INDEPENDENT AIR QUALITY REVIEW
NORTHCONNEX (M1-M2) PROJECT
SSI-6136

Department of Planning and Environment

12 January 2015

INDEPENDENT AIR QUALITY REVIEW

Figure 1: Maximum hourly stack emission rates and concentrations

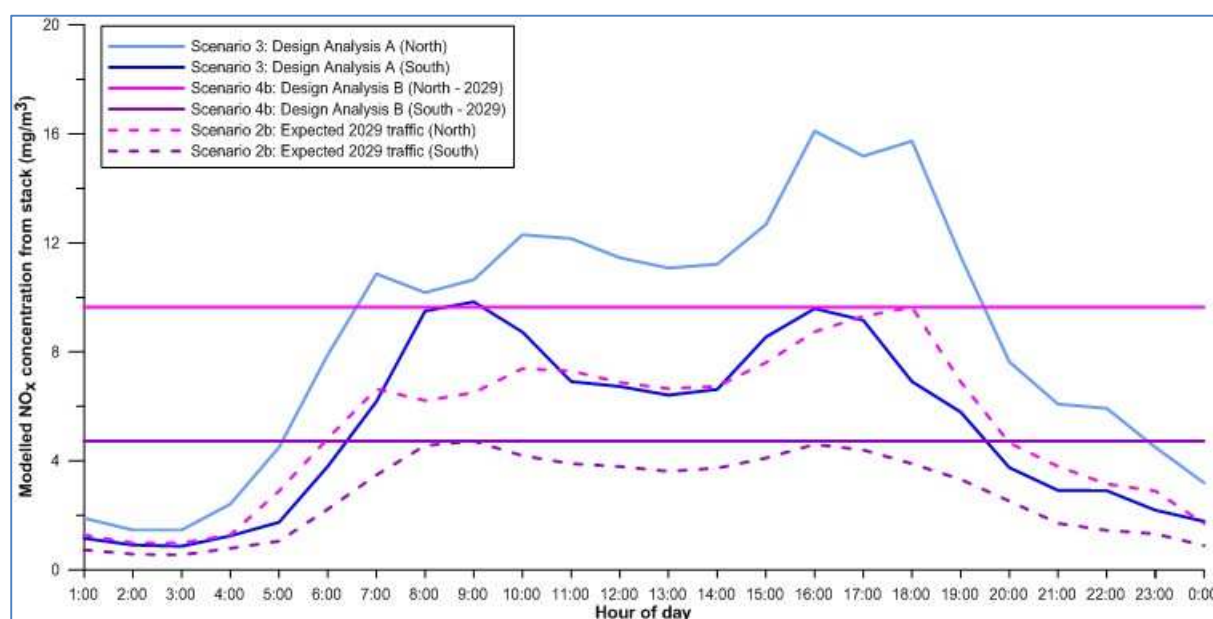
Figure 1 shows that:

The review also considers that it is preferable to provide a relatively realistic estimate of the upper bound of potential effects, and that significantly overestimating impacts at say 2 am (e.g. by approx. a factor of 10 fold per Scenario 4) when there is little actual prospect for such emissions is not ideal.

Figure 2: Visualisation of a typical worst case hour of stack emissions, (plume travelling over elevated terrain)

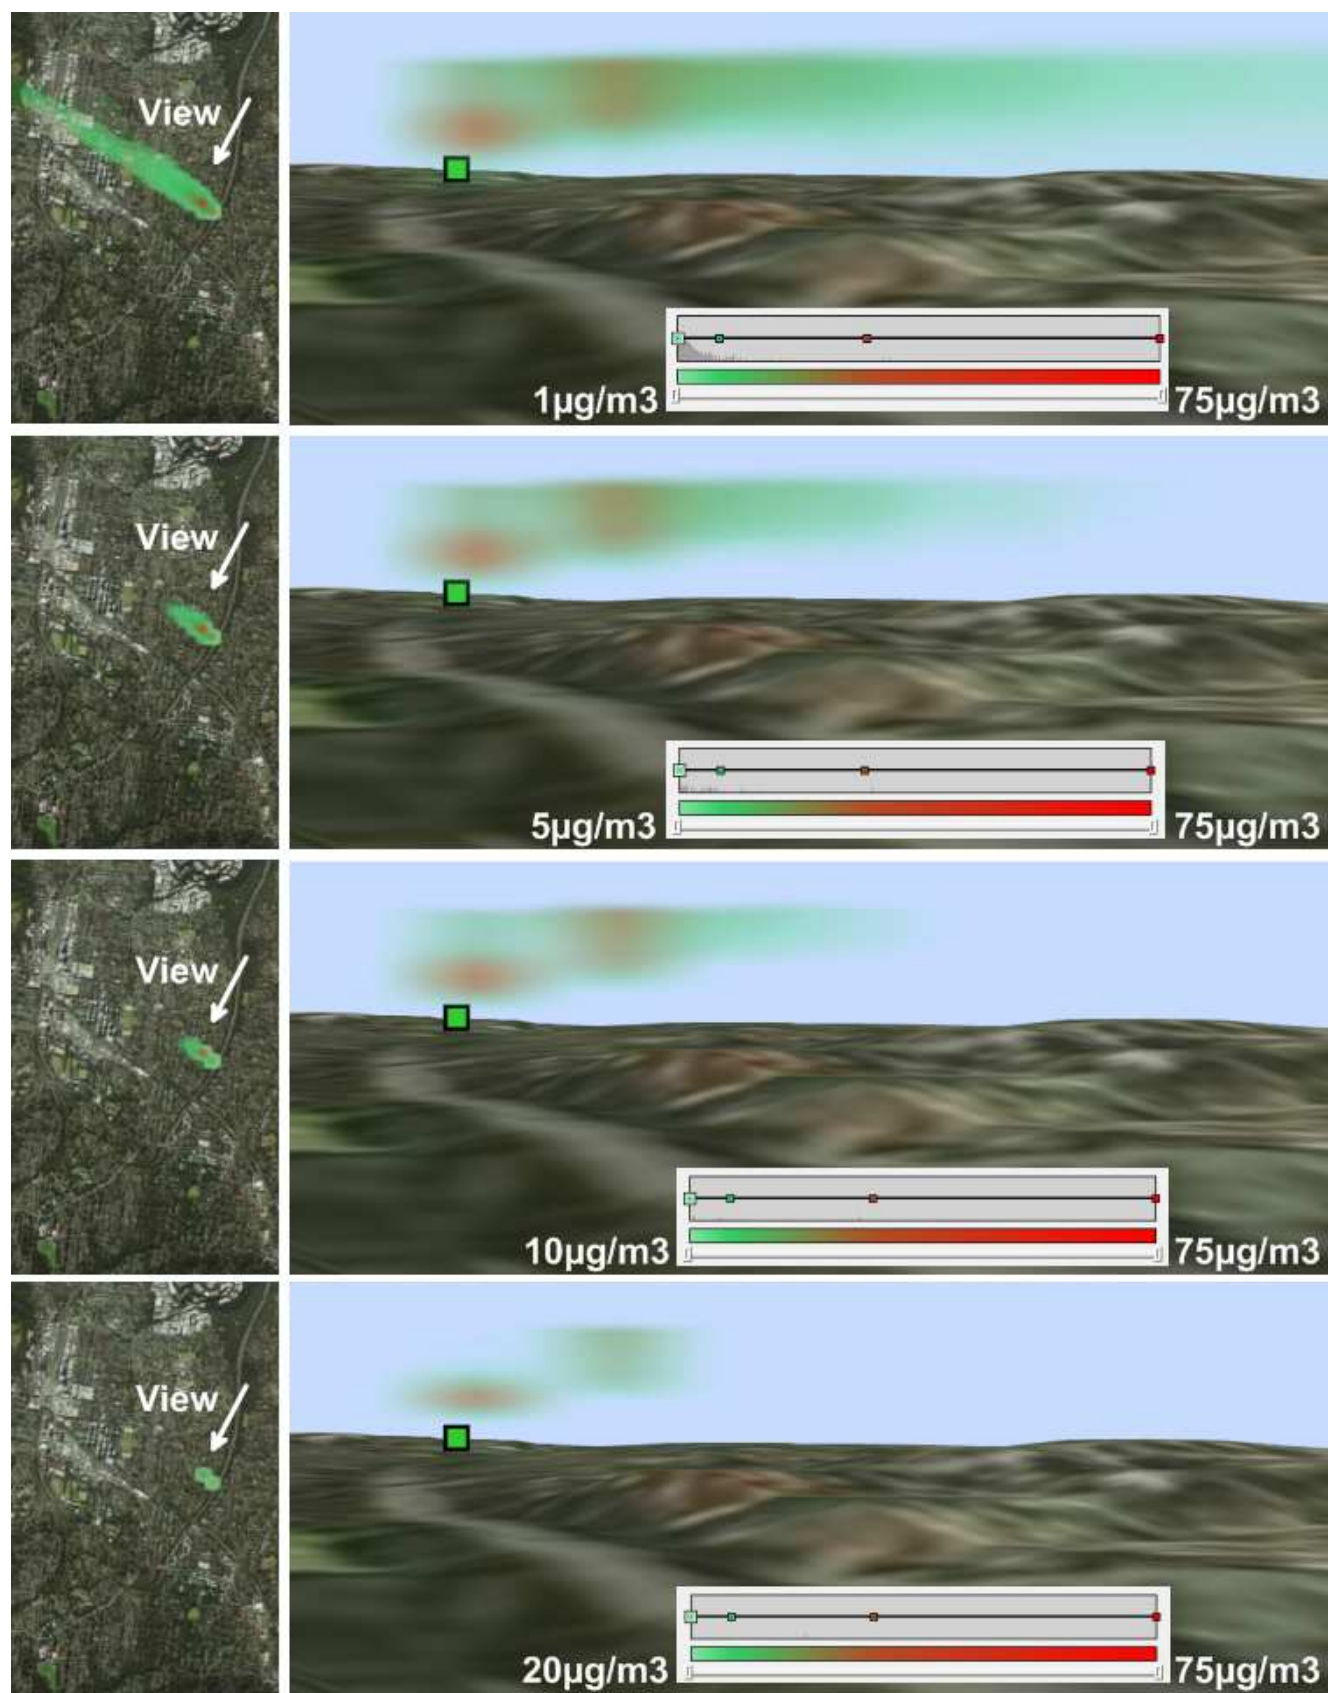
The detailed review of the modelling also examined typical worst case dispersion conditions in detail. The review examined the modelling results using a three dimensional rendering of the outputs, as this is an effective means of finding any technical errors in the modelling. The results presented in the figures below are two dimensional representations of the 3 dimensional analysis conducted. The results and images all show the same 1-hour average stack plume for a poor dispersion condition. Note that the stack emissions plume is cropped at a height of 72 m in this case.

A key observation is that for this poor dispersion situation, with the plume heading directly towards the more elevated terrain, the core of the plume remains well above ground level, and only the well dispersed, low concentration outer parts of the plume interact with the surface or taller buildings. This can be clearly seen in the side view of the plume, (i.e. looking approx. south and along the existing M1 motorway from a position that is the north of the proposed northern ventilation stack location.)

Figure 1 Meteorological Variables on 3 December, 2009 (hours 00 – 23).

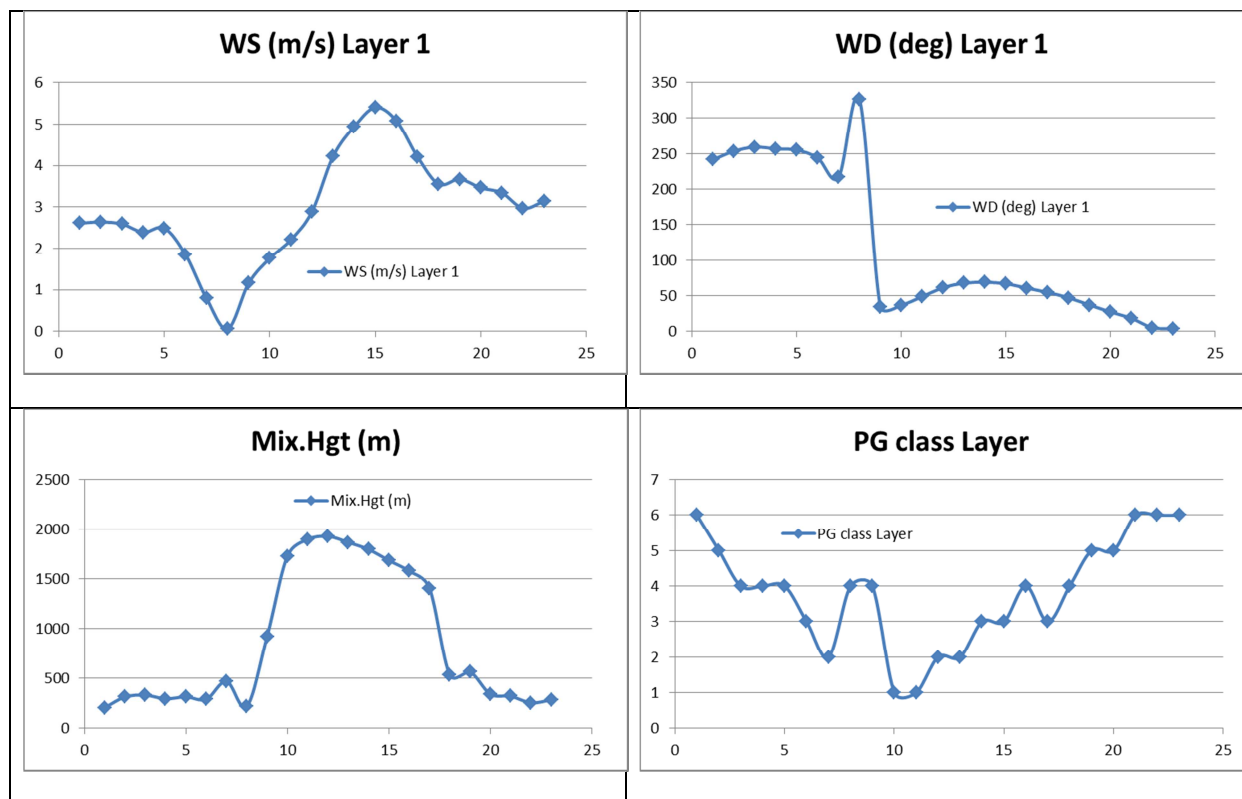
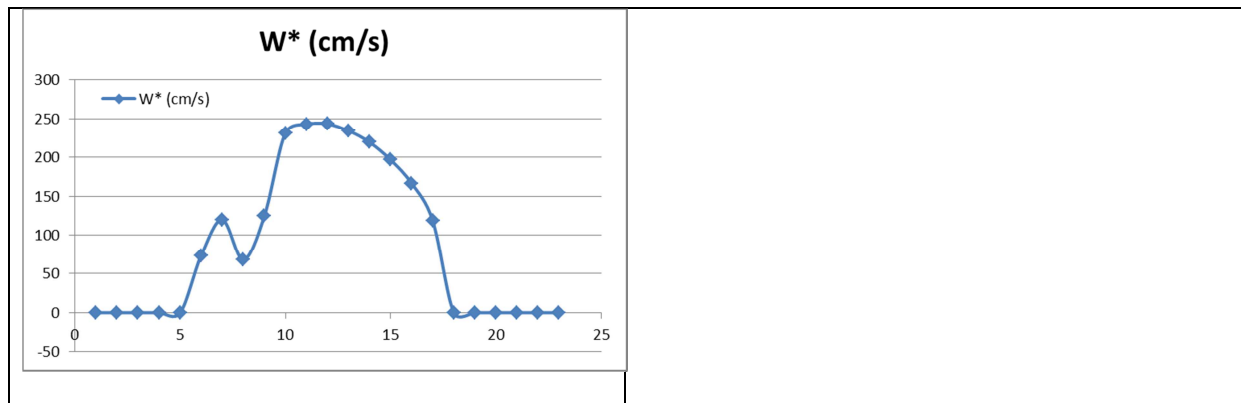
Figure 1 below shows the meteorological variables for this day at the north portal which lead to a peak concentration occurring at 08h00

The meteorological event responsible for the peak concentration is a naturally occurring part of the diurnal cycle of flow in the region. These characteristics are typically ascribed to the shift between off-shore flow during the night which gives way to on-shore winds in the morning. The sea land breeze cycle is likely to occur every single day of the year. However, although this meteorological event occurs mostly every day, there is no other hour in the entire year (2009) or in 2010 or 2011 that produces a peak concentration at this time of the day or at the interchange between the land and sea breeze. Certainly the meteorological events leading up to the peak event are not unusual and it can only be assumed that it is the combination of the massive wind direction change, that lead to a reduction in the stability class, mixing height and wind speed that caused the concentration peak which is a factor of two higher than the next highest concentration.

Figure 2 Concentrations vs Wind Speed. The maximum 'outlier' peak hourly concentrations of JDay 337 and JDay 45 are shown.

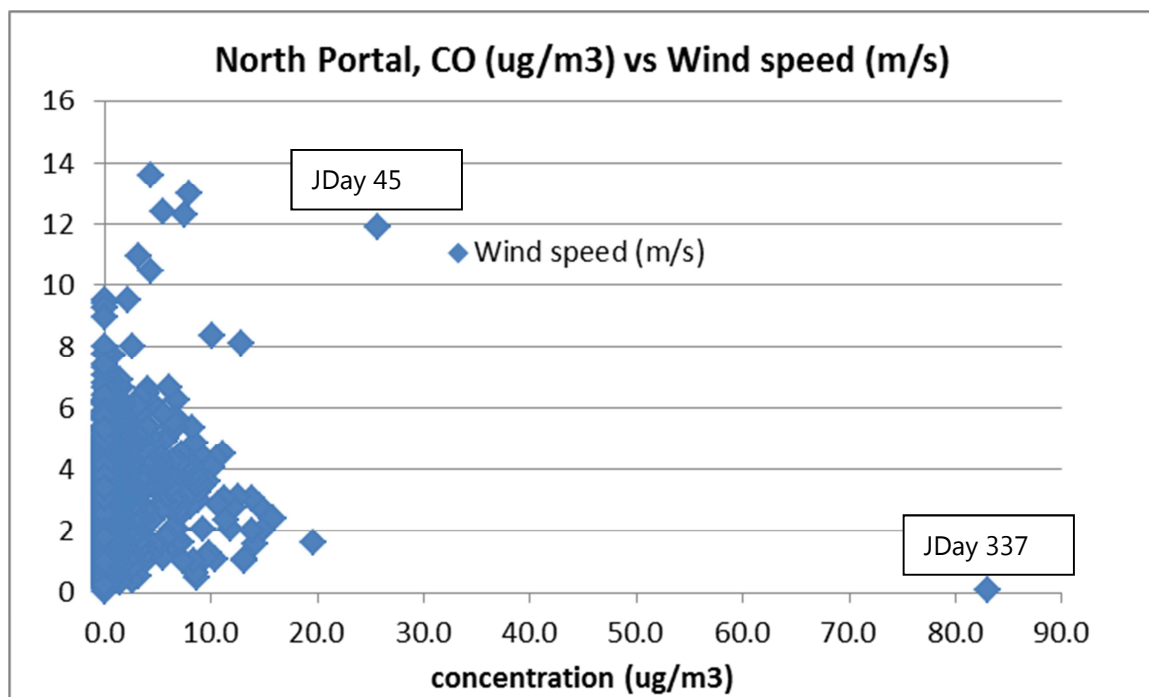
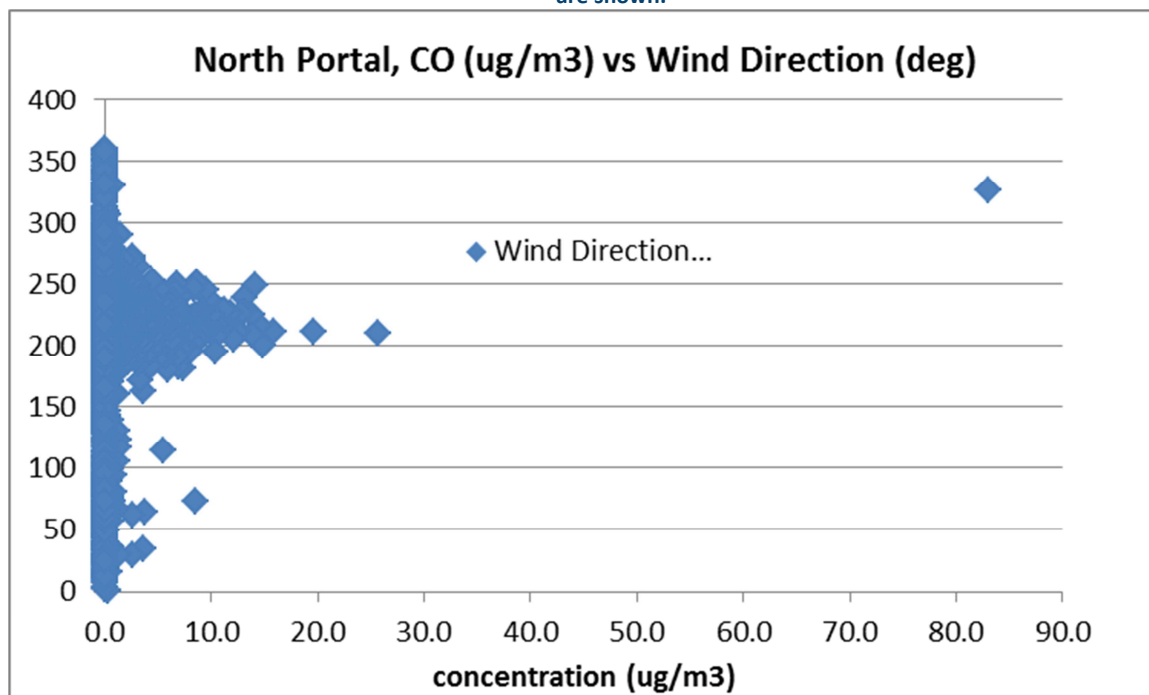
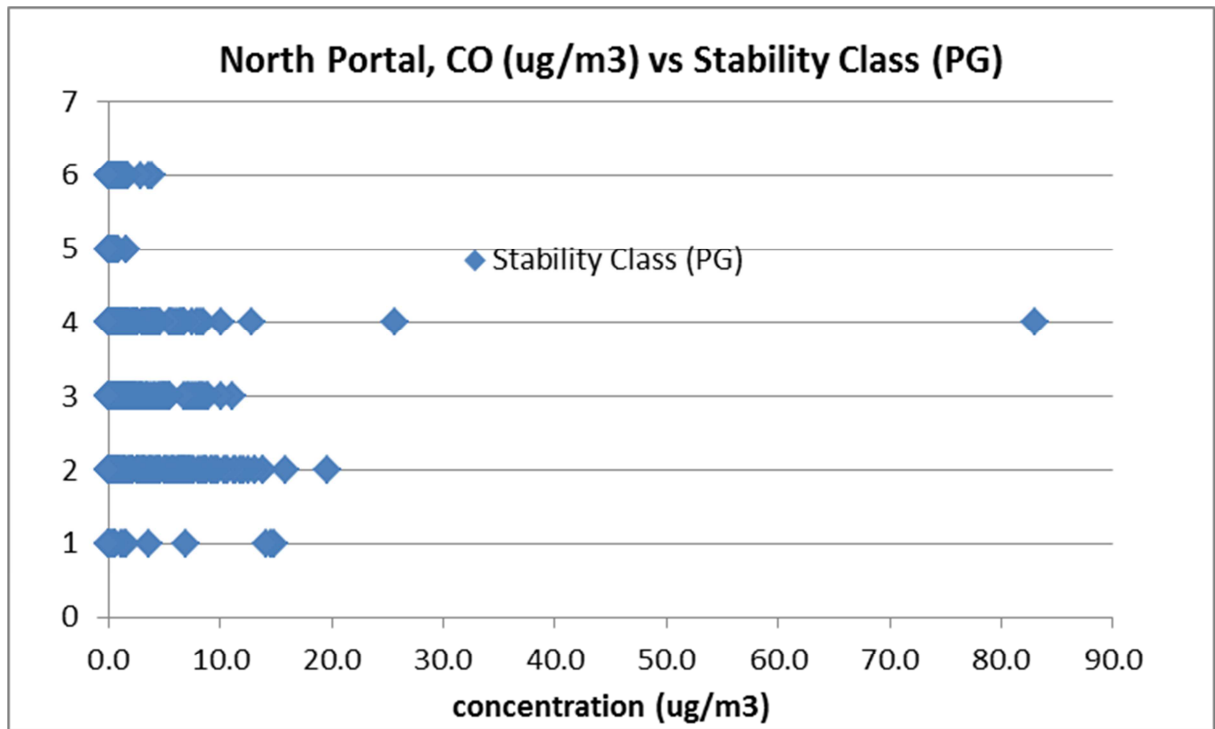
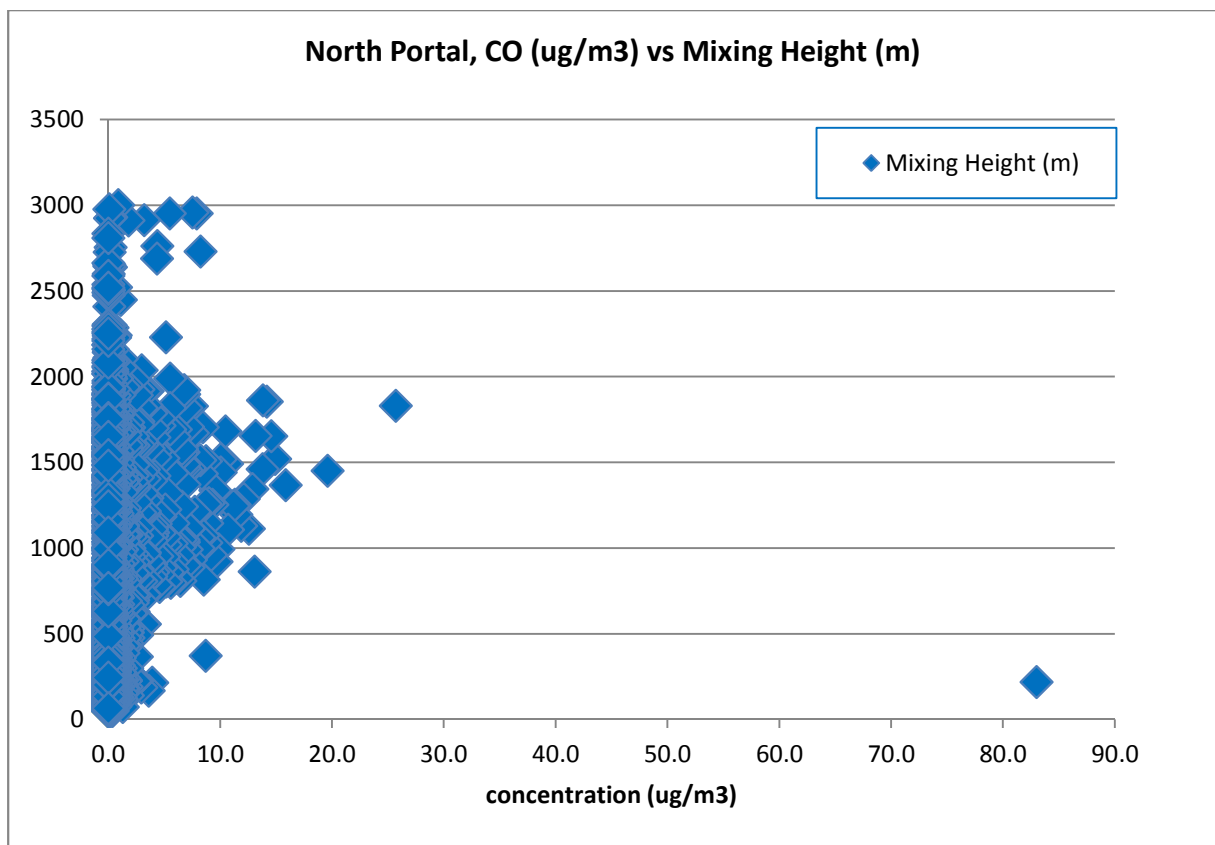
It is important to consider the data in context. Figure 2 shows the spread of concentrations v.s. wind speed at a single receptor. The normal distribution of concentrations is spread across a range of wind speeds, with one outlier (JDay 337) a factor of 2 times higher than the second highest concentration. If we considered the 99.9th percentile of the data, rather than the maximum which in this case is a single outlier then the spurious data would disappear.

The modelling results clearly show that the single result recorded on hour 8, day 337 does not fit the normal distribution of data observed for all other meteorological conditions and can clearly be considered to be an outlier.
